August 1, 2025

**RE: LSPGC Response to CPUC Data Request #8 for LS Power Grid California, LLC's
Collinsville 500/230 Kilovolt Substation Project (A.24-07-018)**

Figure 1 Alternative 1

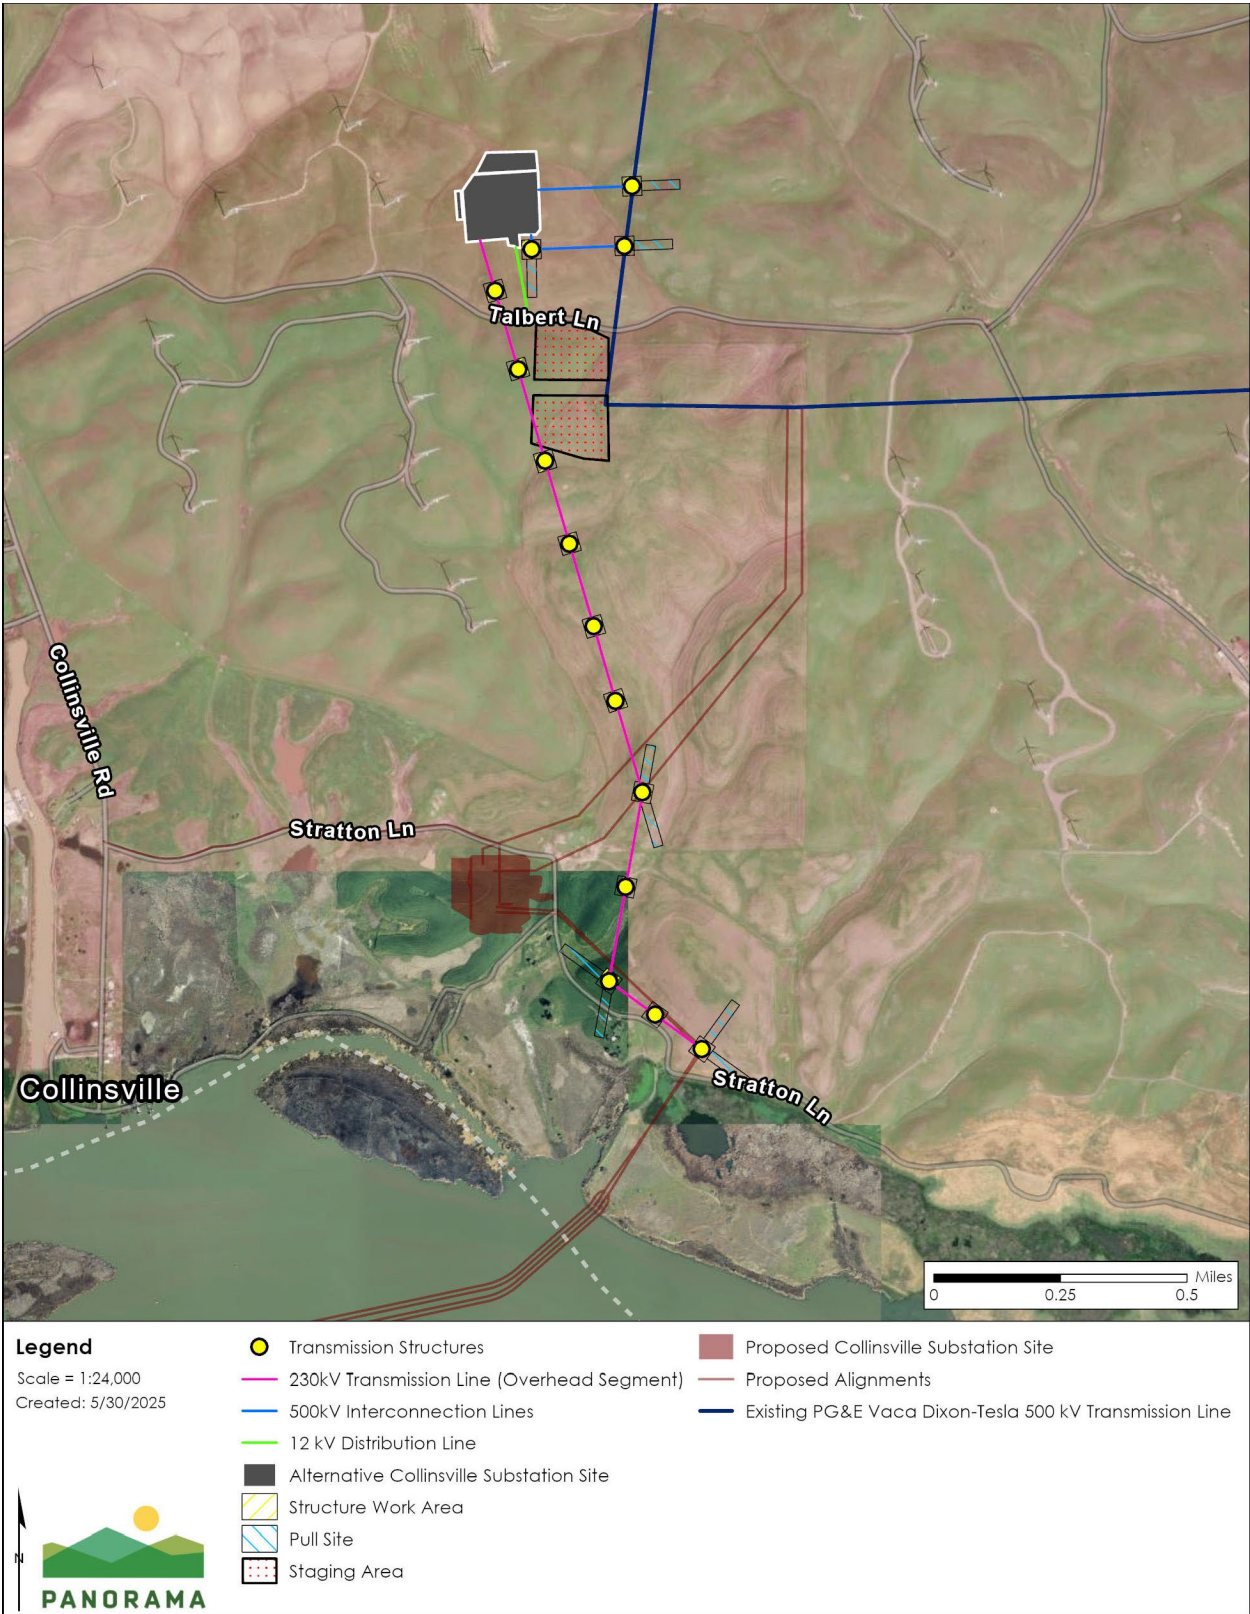
Section/Page Reference	CPUC Comment	Request ID	CPUC Request	LSPGC/PG&E Response
n/a	<p>DR-4: Alternative 1 and Alternative 2 Substations 500 kV Interconnection Line Structures</p> <p>The GIS data provided appears to show one 500 kV interconnection LST just south of the Alternative 1 substation and no structures for the northern line within the substation or adjacent the substation (see Figure 1 below). Where would the northern line tie into the substation? Would the southern 500 kV LST be a transition structure or a separate LST with a separate transition structure located within the substation?</p> <p>The GIS data provided appears to show one 500 kV interconnection LST just north of the Alternative 2 substation and no structures for the southern line within or adjacent the substation (See Figure 2 below). Where would the southern line tie into the substation? Would the northern 500 kV LST be a transition structure or a separate LST with a separate transition structure located within the substation?</p>	4	Please review the Figures for Alternative 1 and Alternative 2 below and provide updated GIS data that reflects the location of the structures for the northern and southern 500 kV interconnection lines for each alternative respectively. Please also clarify if the poles for the 500 kV interconnection lines in each case would be LSTs or TSPs.	The structures depicted in the Figures for Alternative 1 and Alternative 2 accurately represent the locations of the northern and southern 500 kV interconnection line structures for each respective alternative. It should be noted that A-Frame structures, which will be situated within the substation fence line, are not illustrated in the Figures.
